CONDITIONAL USE APPLICATION

Project/Property Address or Location: 4297 and 4301 Johnstown Road, Columbus, Ohio 43230		Project Name/Business Name (if applicable):	
Parcel ID No.(s): 027-000142 & 027-000098	Current Zoning: ER-2, Estate Residential	Total Acreage: 2.87 +/- Acres	
Proposed Use/Timeframe: To allow the following uses to operate on the property under the SO, Suburban Office classification: Medical and dental laboratories, health and allied services, not elsewhere classified and Services, not elsewhere classified.			
STAFF USE ONLY – Conditional Use: 1153.01(b) conditional uses - 807, 8099, 899			
APPLICANT Name (primary contact) -do <u>not</u> use a business name: 4297 Johnstown Road LLC, c/o Underhill & Hodge LLC		Applicant Address: 8000 Walton Parkway, Suite 260, New Albany, OH 43054	
Applicant E-mail:		Applicant Phone No.:	
BUSINESS Name (if applicable):			
ATTORNEY/AGENT Name: Aaron L. Underhill, Esq., Underhill & Hodge LLC		Attorney/Agent Address: 8000 Walton Parkway, Suite 260, New Albany, OH 43054

CITY OF GAHANNA
GAS LIGHT SQUARE
FRANKLIN COUNTY, OHIO

RE: Project 4297-4301 Johnstown Rd Conditional Use Comments

SITE ANALYSIS PLAN

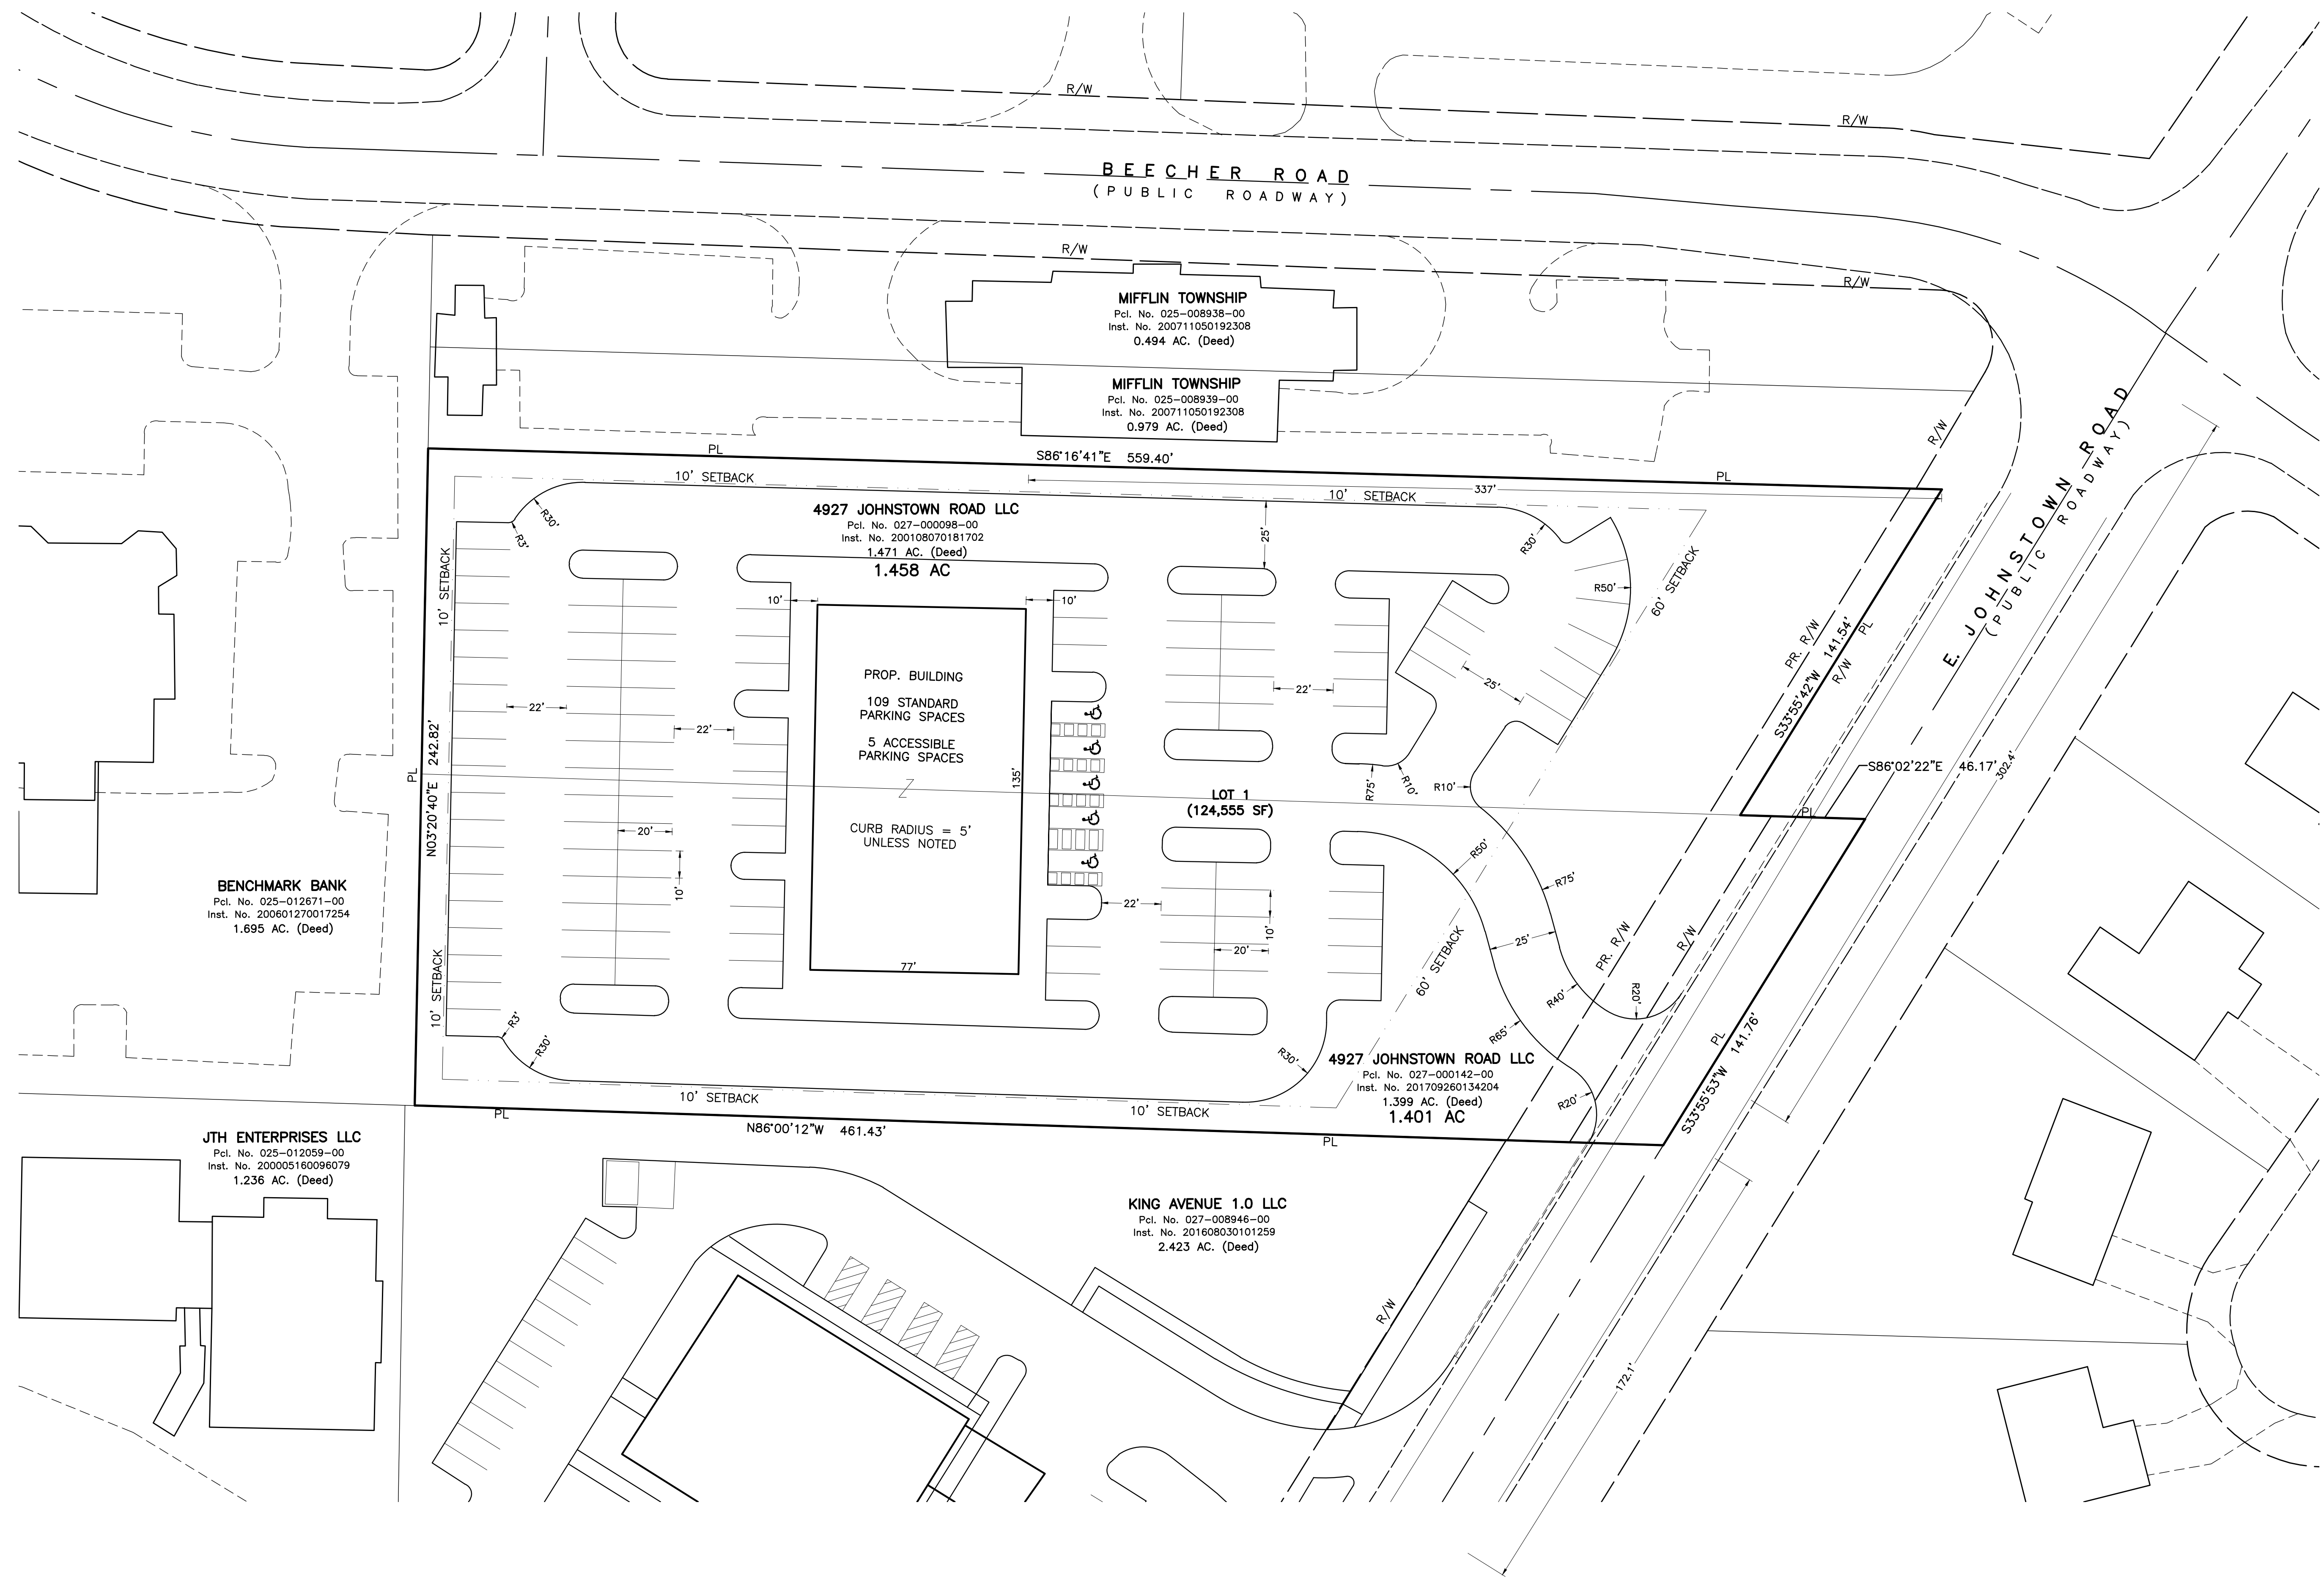
1. This site contains a very active ground water component in the Pewamo hydric soil type. This location and the adjacent parcel to the south have in the past been subject to prolonged inundation and surface runoff. The development to the south has drastically changed contours and installed underground storage to accommodate drainage. Changes to this site will likely include fill to match and potentially have an impact on both groundwater and surface runoff. Storm water development requirements may not account for some of these effects.
Site drainage will be important to the long term potential of this site and areas associated with this area of Pewamo soil.

Scale: 1" = 40'
Dwg. Title: **SURVEY**
Sheet: **1-1**

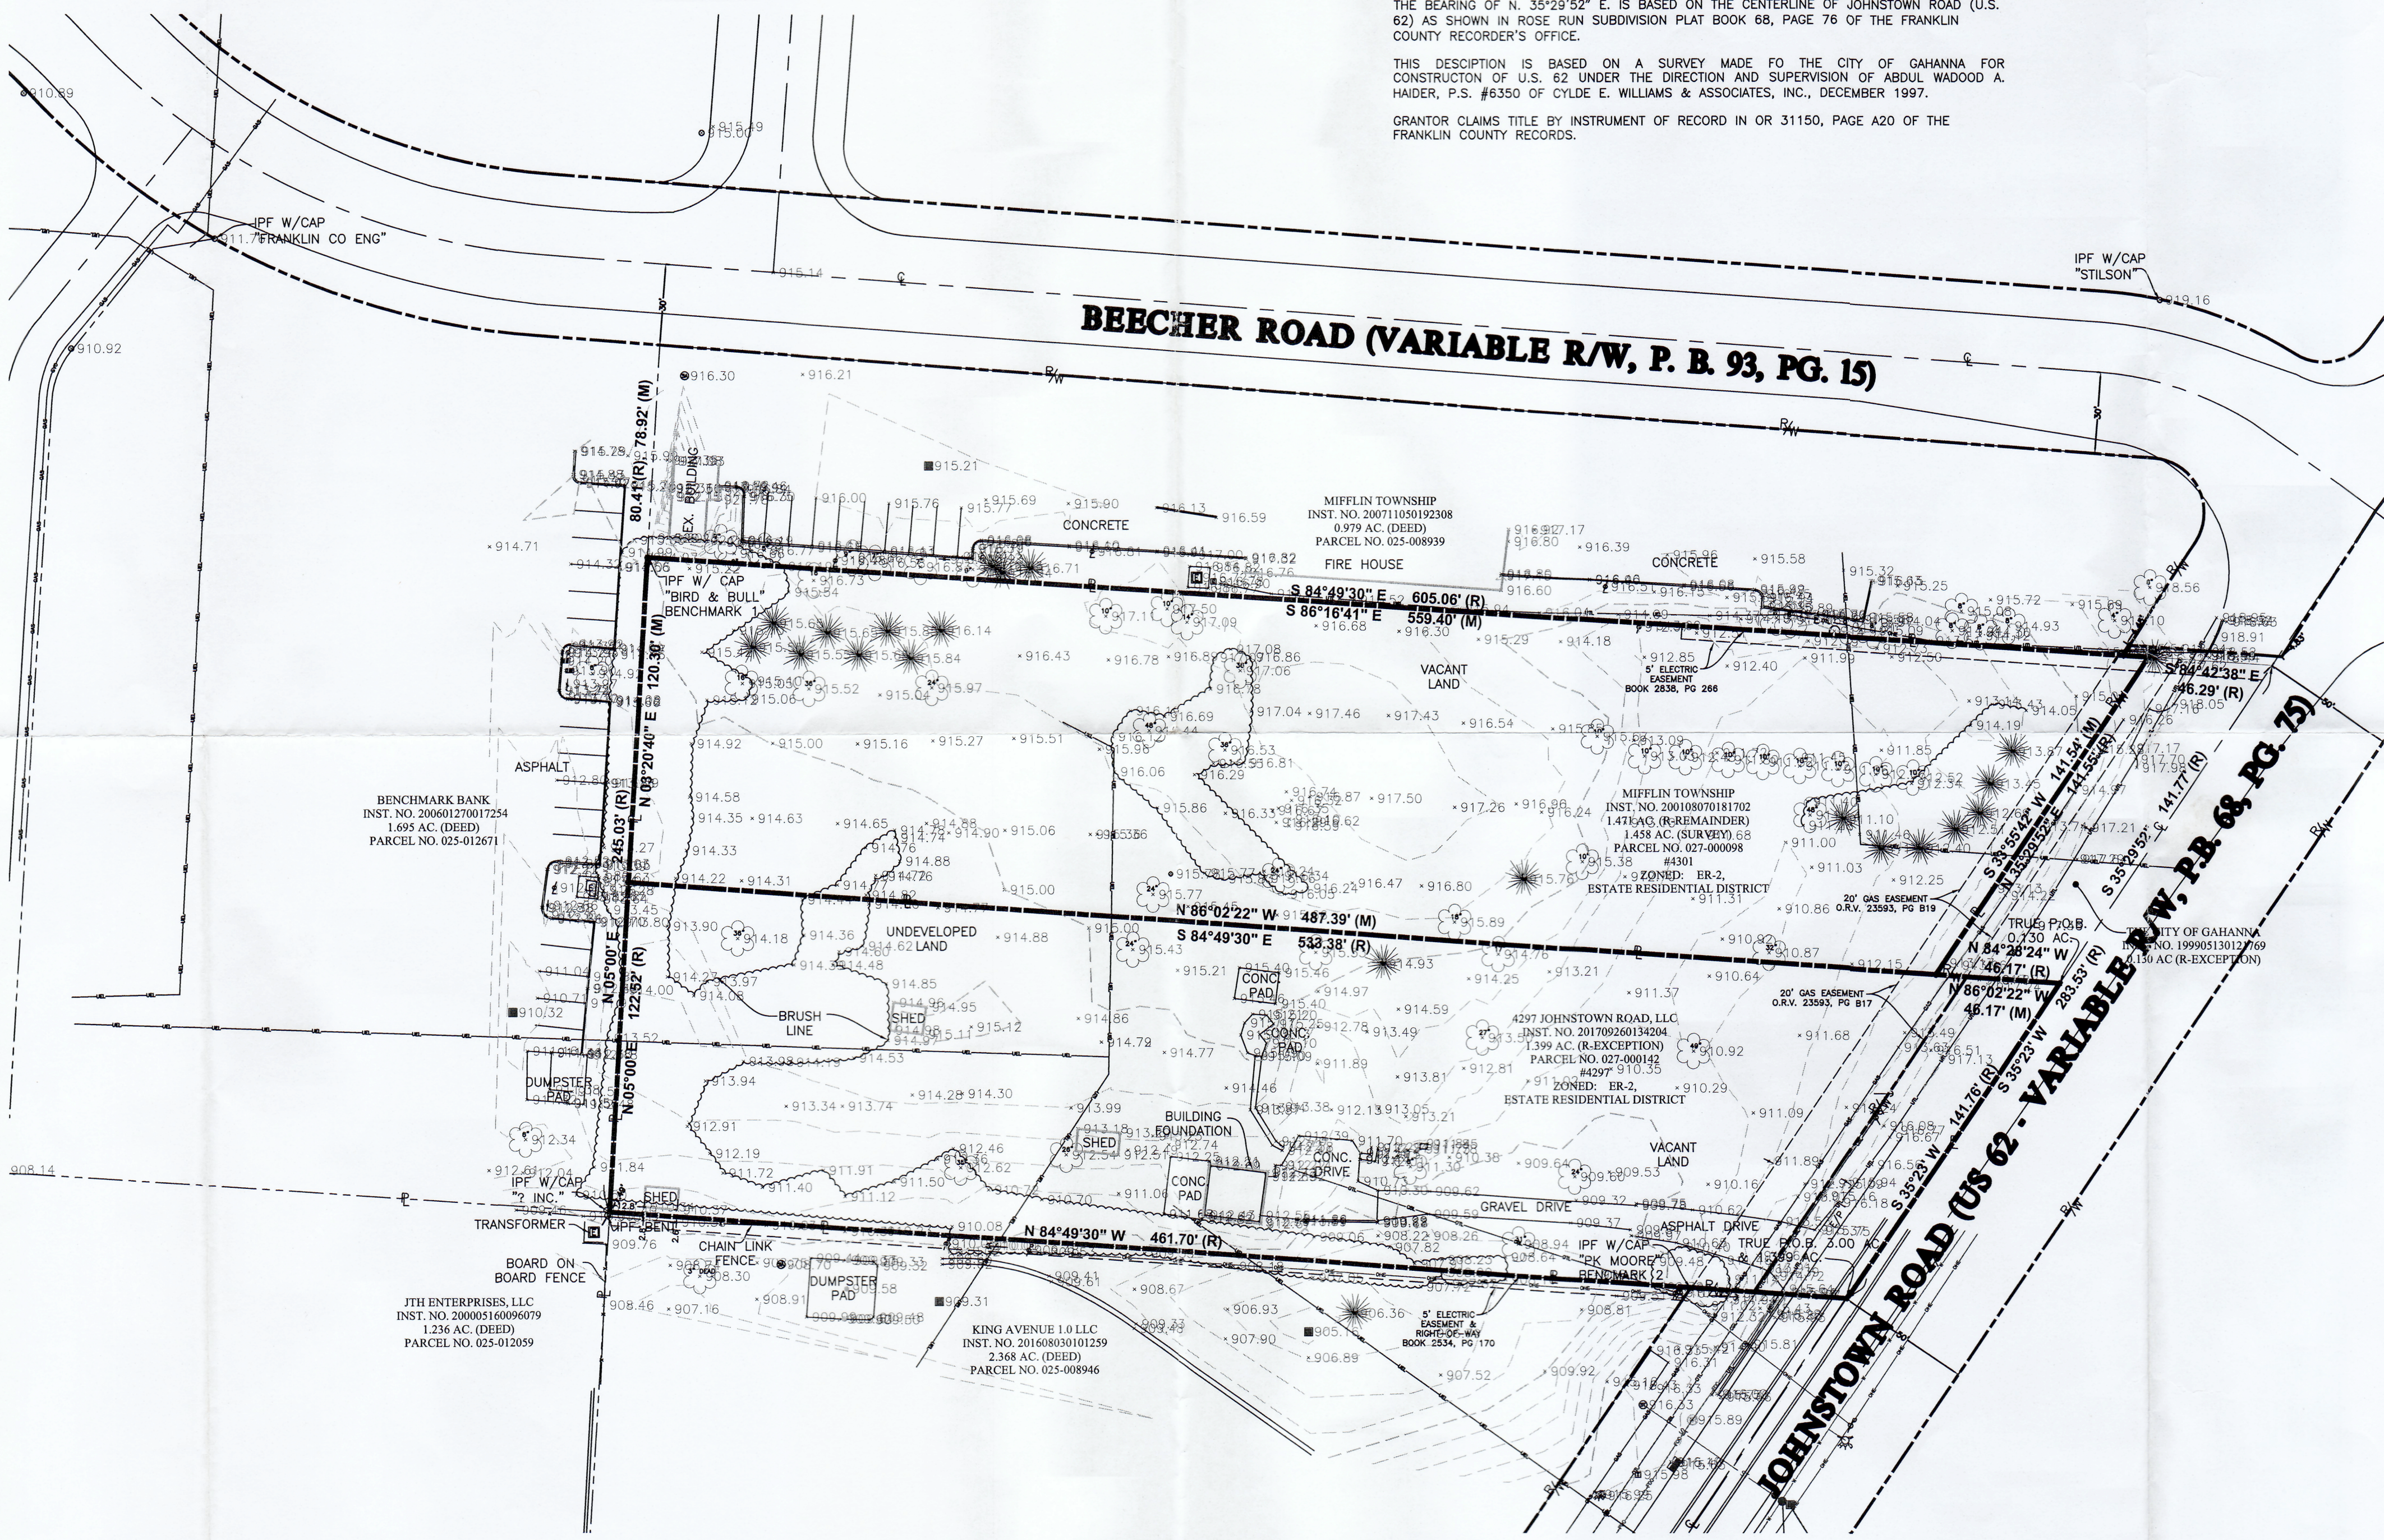
Connect to Kidney Center for in/out, Add sidewalks, Nice landscaping on Johnstown, Building closer to frontage, Parking in Back Access to Beecher? thru Fire Property. or thru Union Bank

With this site plan, I would reduce the amount of parking spaces and add more landscaping/tree preservation.
